CERTIFICATE OF APPROPRIATENESS PLACARD

105 S BLOODWORTH STREET

143-17-MW

RE: 162-16-CA (105 S Bloodworth Street)—Approved as Amended with Conditions

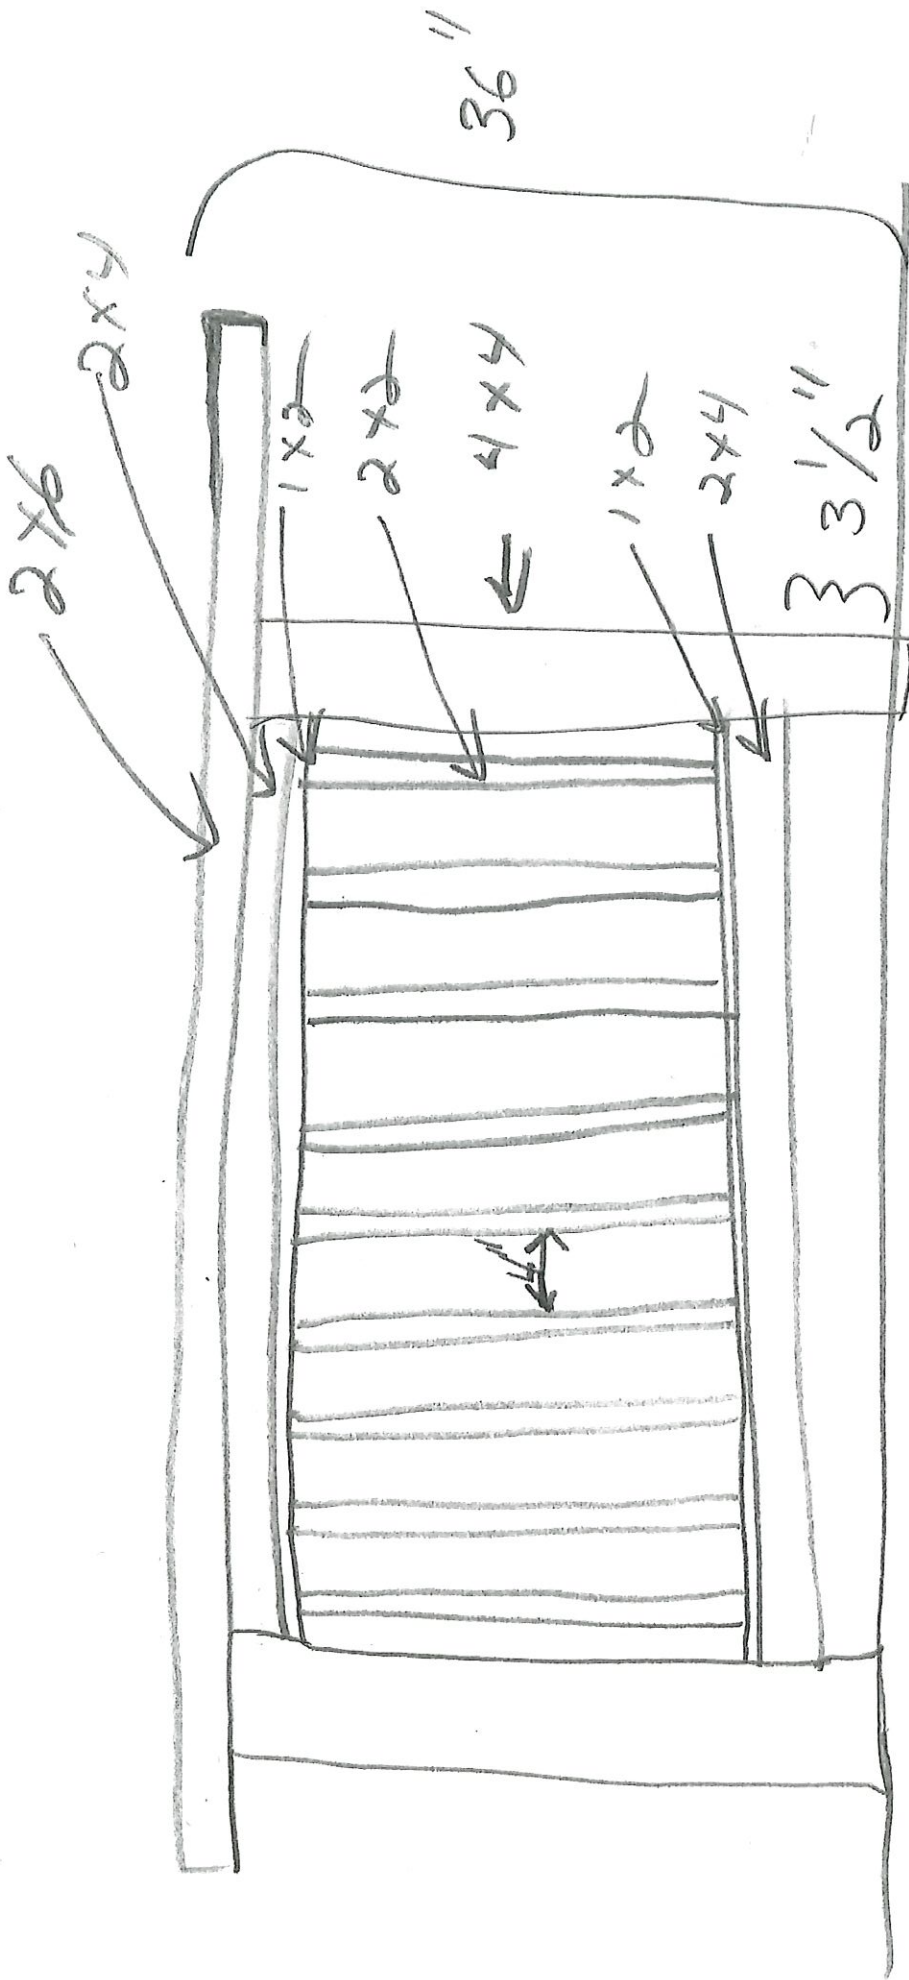
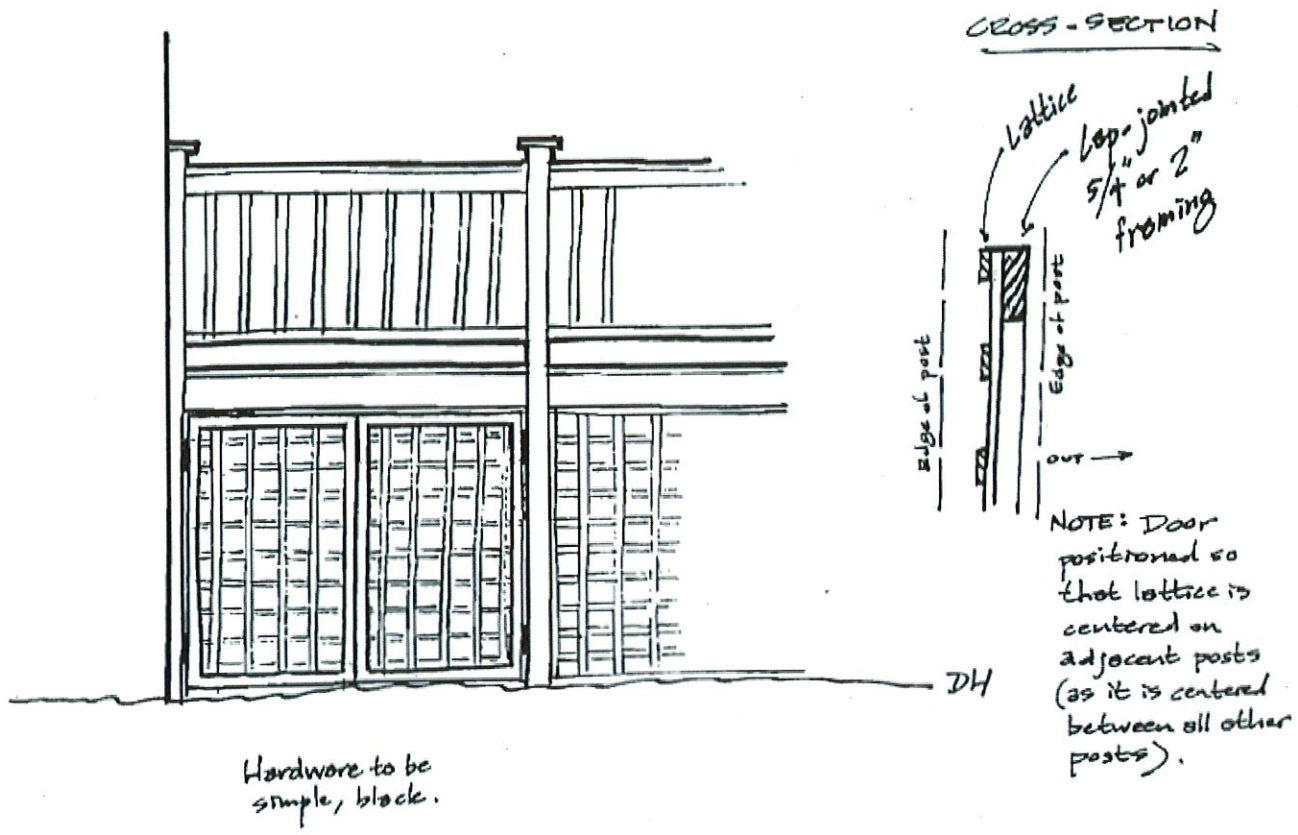
1. That the railing balusters have the appearance of inset pickets and not be face-applied. – **See 2.b below.**
2. That details for the following items be provided to staff for review and approval prior to issuance of the blue placard and construction of the deck:

- a. Structural details for the deck and balcony; - **This condition has been satisfied.**
 - b. Cross section details for guardrails, deck and balcony decking/bandboard treatment and lattice attachment; - Please look at the attachment to see the level of detail we need for these elements. The engineer's drawings showed how the structure will be framed, but none of the design details. Please see condition 1 for the desing requirements for the railings.**

- That the railing balusters have the appearance of inset pickets and not be face-applied. – **See 2.b below.***WE WILL MAKE SURE THEY ARE INSET, SEE THE DRAWINGS ATTACHED.****
- That details for the following items be provided to staff for review and approval prior to issuance of the blue placard and construction of the deck:
 - a. Structural details for the deck and balcony; - **This condition has been satisfied.**
 - b. Cross section details for guardrails, deck and balcony decking/bandboard treatment and lattice attachment; - **Please look at the attachment to see the level of detail we need for these elements. The engineer's drawings showed how the structure will be framed, but none of the design details. Please see condition 1 for the desing requirements for the railings.**

*****SEE THE DRAWINGS ATTACHED. WE WILL MATCH THE SAMPLE YOU SENT FOR THE LATTICE WORK ON THE PAGE LABELED "LatticeWork" I'VE ALSO ATTACHED A SKETCH OF HIS DRAWING OF PROPOSED RAILS.****

Safety bollards

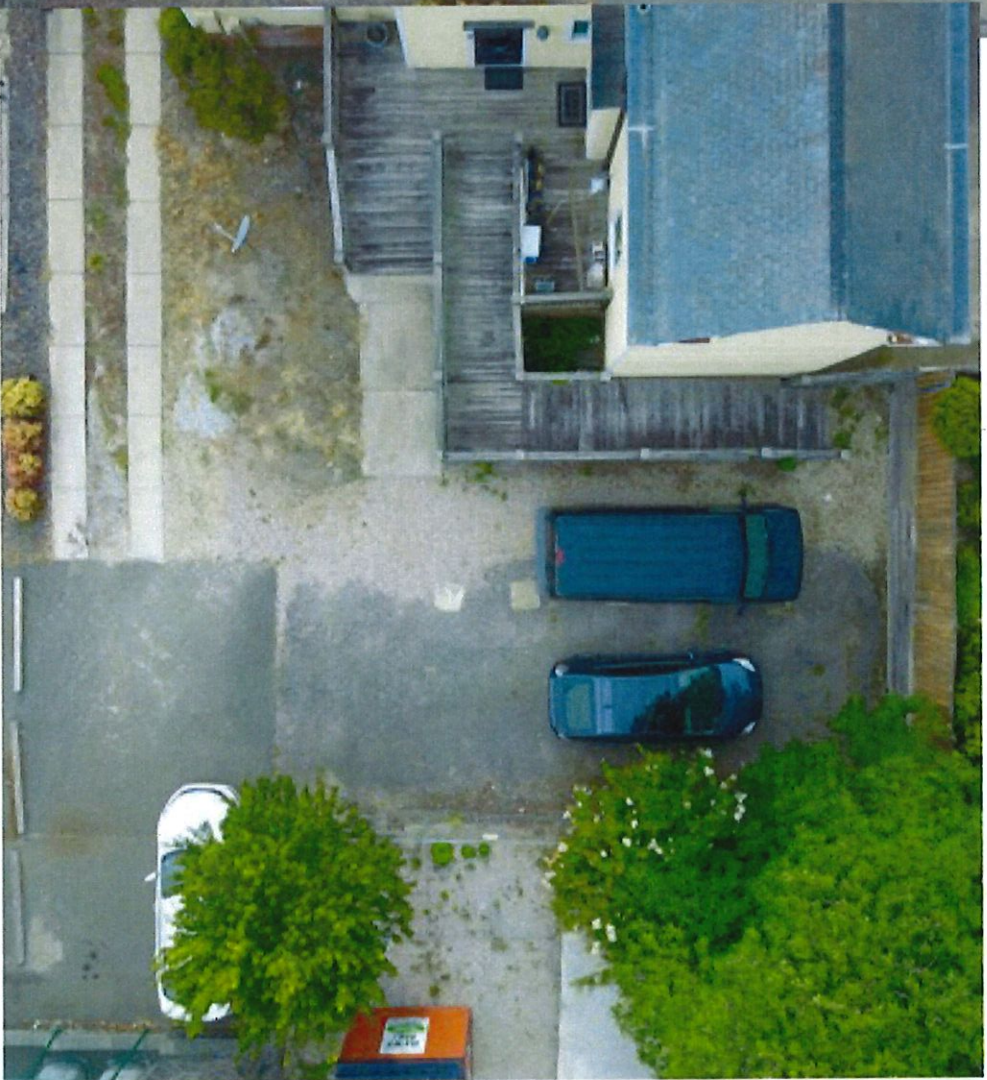
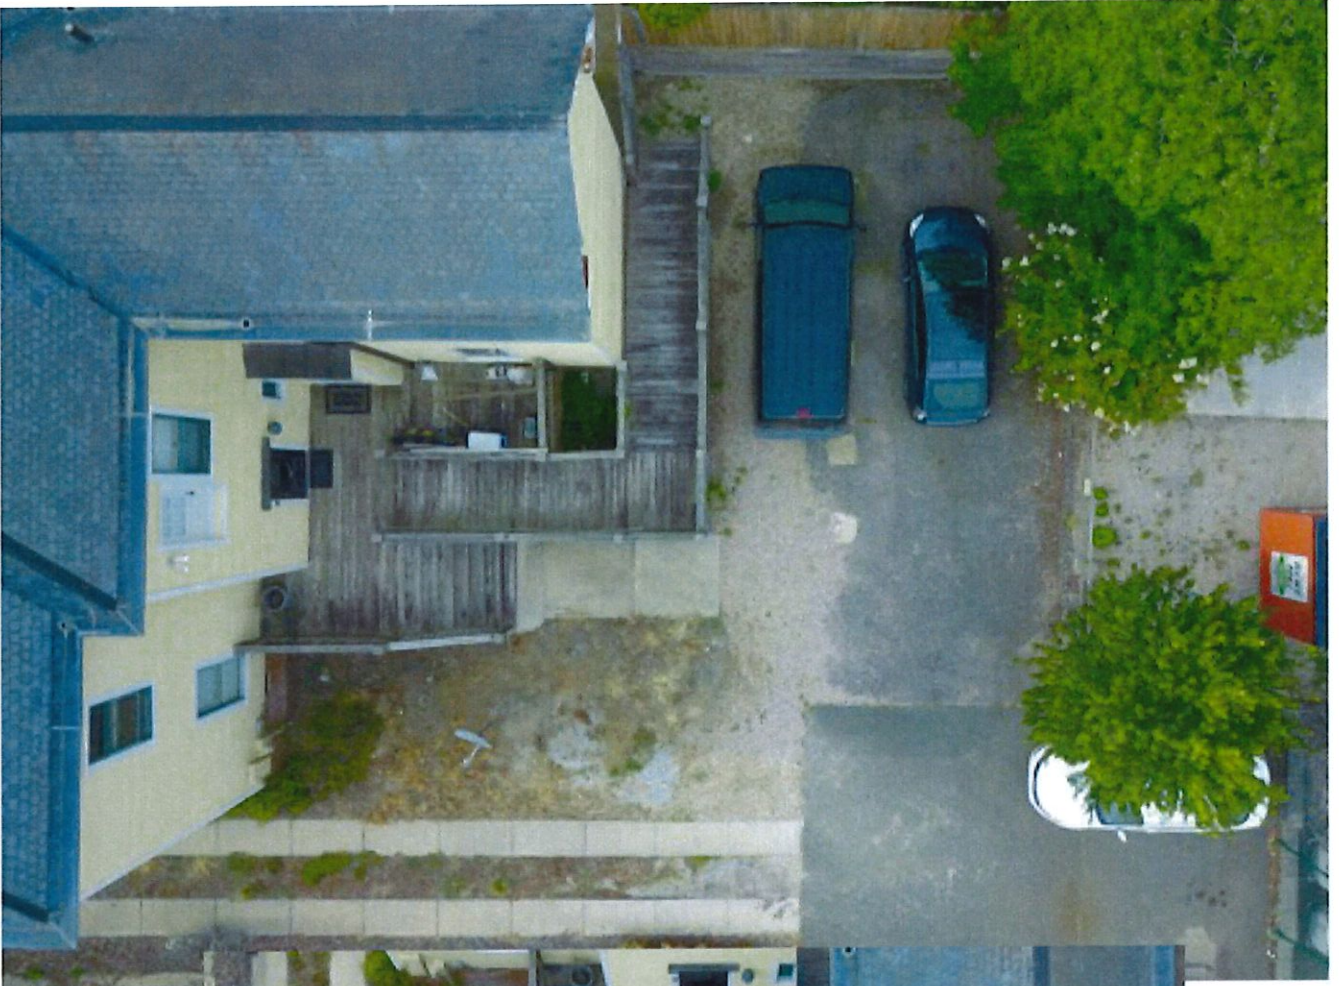
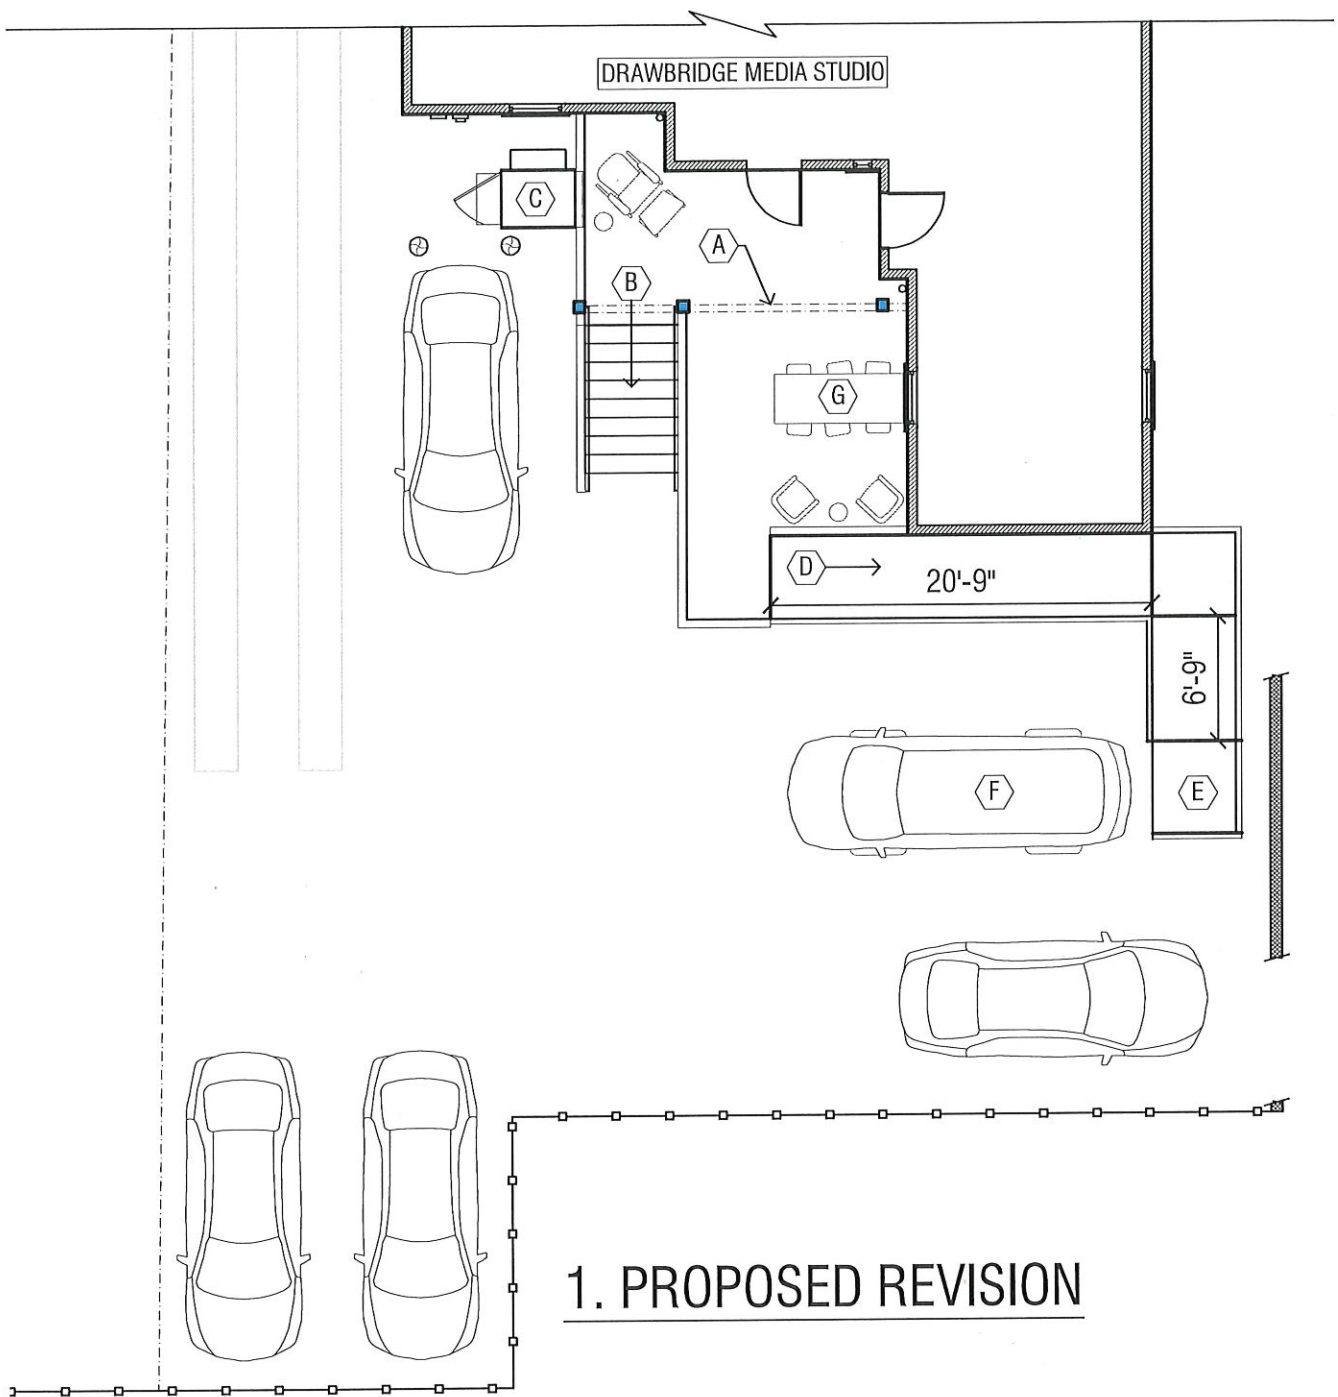
- e. Protective bollards; **The bollards chosen are approvable, however the color is not. If you paint them the same white as on the trim of the house that might work. Please let us know you final selection.**

*****WE WILL PAINT THE BOLLARDS WHITE TO MATCH THE TRIM****

PER APPLICANT -
BOLLARDS TO
BE PAINTED
WHITE TO
MATCH HOUSE
TRIM
8/30/17
